SUBJECT: Forwards info justifying lower values of integrated dose used in qualification of electrical equipment contained inside reactor bldg, per NRC 820209 request. Includes bases & assumptions used in analysis & sample calculation.

Subject: Oconee Nuclear Station
Docket Nos. 50-269, -270, -287

Response to NRC Request for Additional Information Concerning Radiation dose Determination for Equipment Located Inside the Reactor Building.

ATTACHMENT I
NORMALIZED INTEGRATED
DOSE Vs. TIME

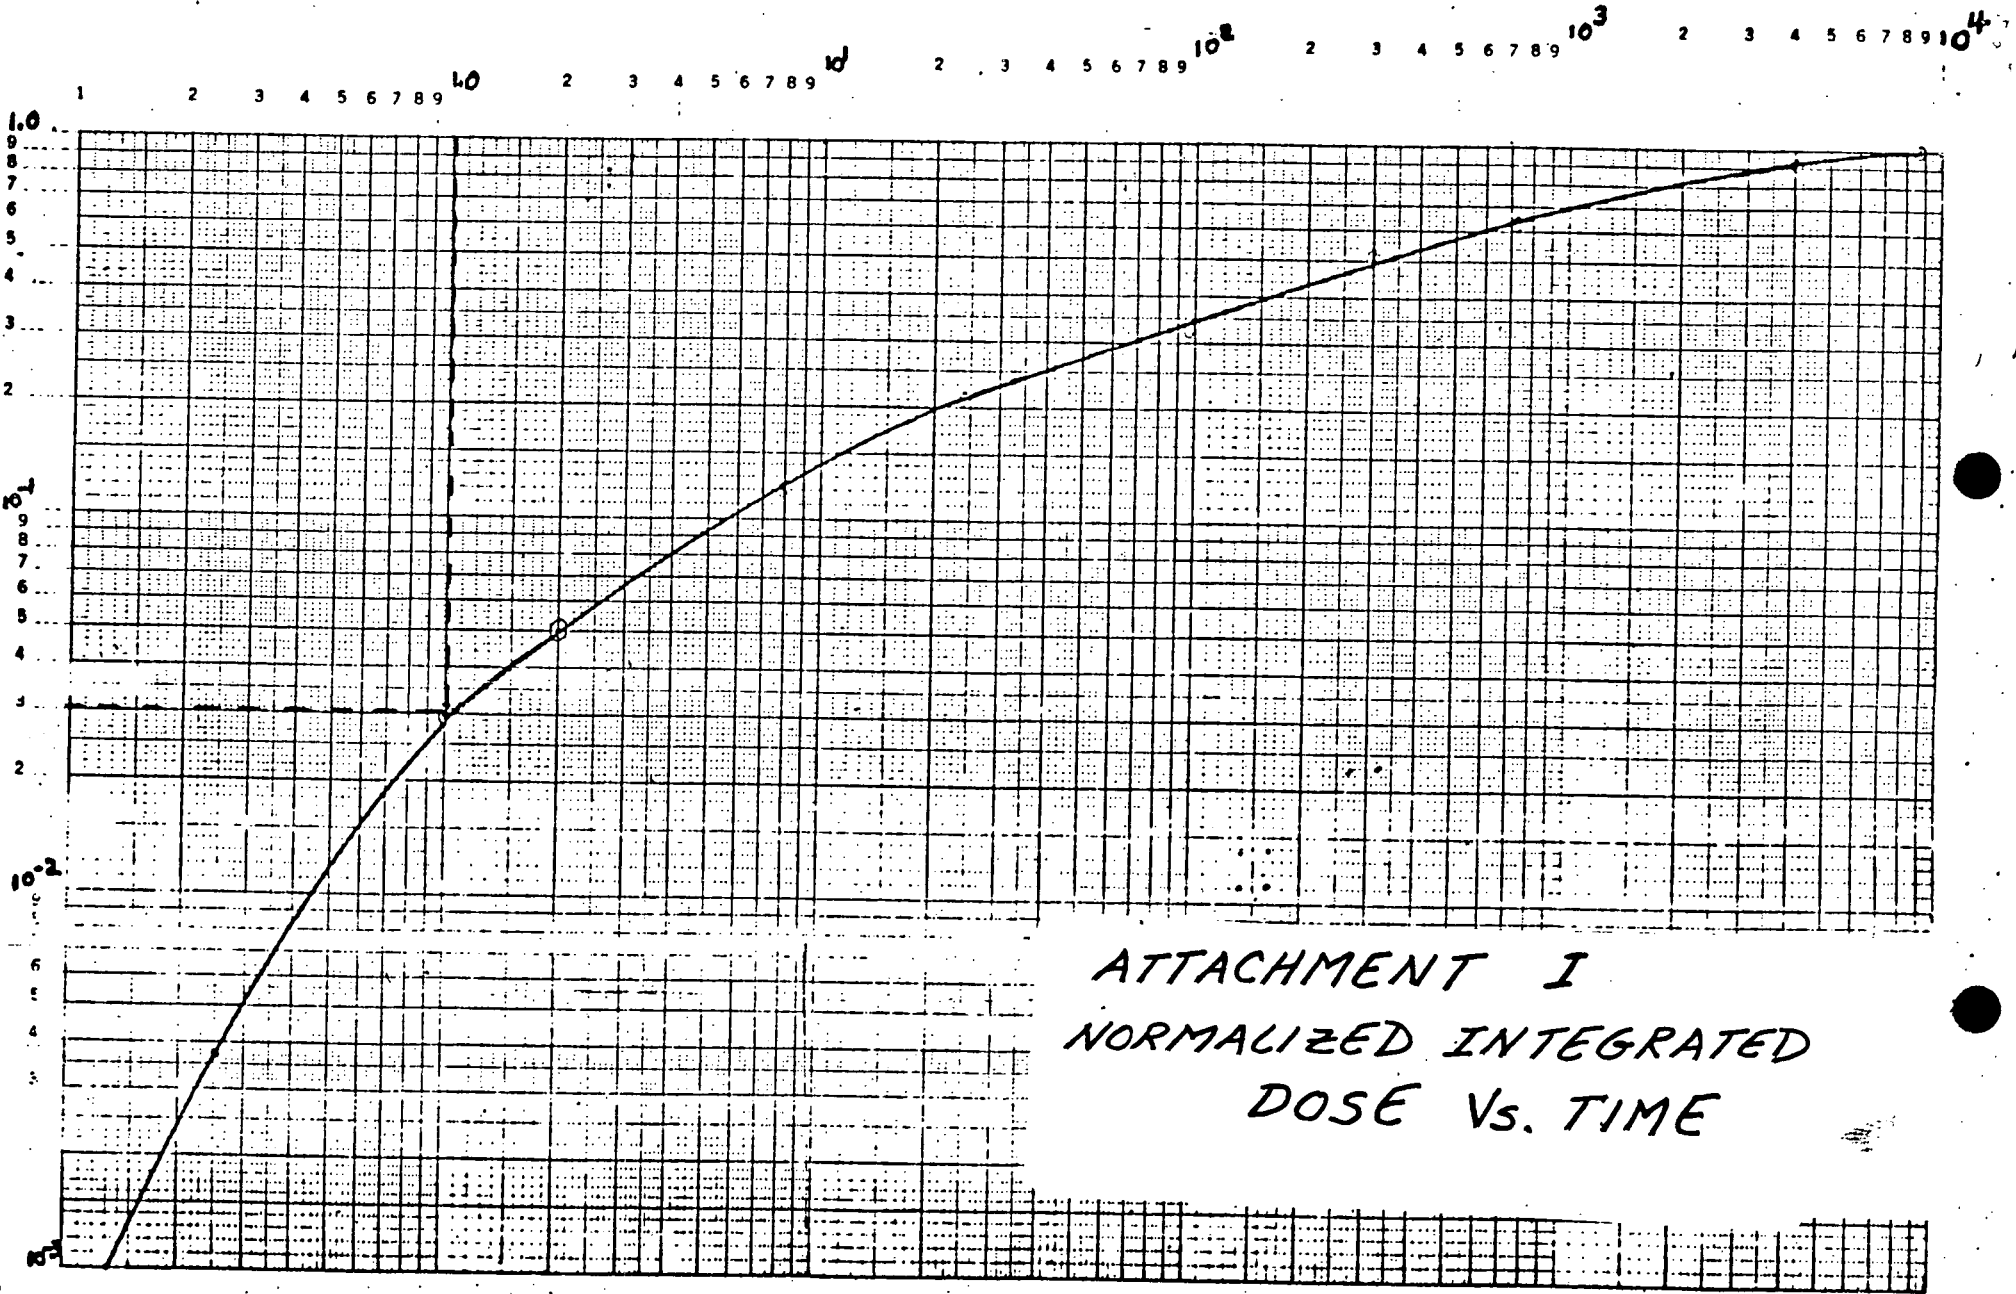
By letter dated February 9, 1982, the NRC Staff requested that information be provided that justifies lower values of integrated dose used in the qualification of electrical equipment contained inside the Reactor Building.

Attachment I, "Normalized Integrated Dose vs. Time", was developed from the rate decay curve by dividing the integrated dose rate for a time period less than 1-year by the post-LOCA 1-year TID. By utilizing this curve the fraction of the post-LOCA 1-year TID received by a piece of equipment up to one year can be determined. It should also be noted that the 40-year normal TID is a function of Reactor operation and equipment location.

$$\text{FRACTION OF 1-YEAR POST-LOCA TID FROM ATTACHMENT 1} = .0298$$

This transmitter has been qualified to operate in a radiation environment of 2.2×10^6 Rads TID (B & W TR-58-0093-00). Therefore, it must be determined if the 40-year normal integrated dose plus the 1 hour post-LOCA TID is greater than 2.2×10^6 Rads.

The analysis confirms that the qualified radiation values for this transmitter exceeds the combined 40-year normal and accident dose calculated for the location of this device.
